## STATE OF MAINE DEPARTMENT OF TRANSPORTATION 16 STATE HOUSE STATION AUGUSTA, MAINE 04333-0016

October 19, 2006 Subject: Calais/St. Stephens Project No. NCPD/CBI-8483(360)X Pin No. 8483.36 Amendment No. 3

## Special Provision 100 Environmental Requirements and Commitments

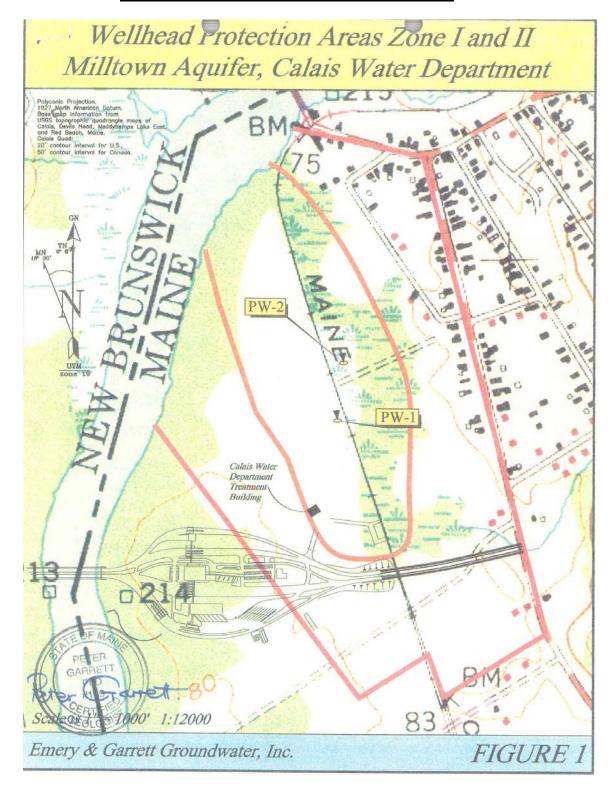
In the book, within "Special Provision 100, Environmental Requirements and Commitments" REMOVE the map on page five of five and REPLACE with the new attached map.

**Question:** No refueling can take place within the wellhead area of the City of Calais water supply. Where are the limits of the wellhead areas Zone1 and Zone 2?

**Response:** As stated in 656.17, paragraph 17) see the map within "Special Provision 100, Environmental Requirements and Commitments" page five of five.
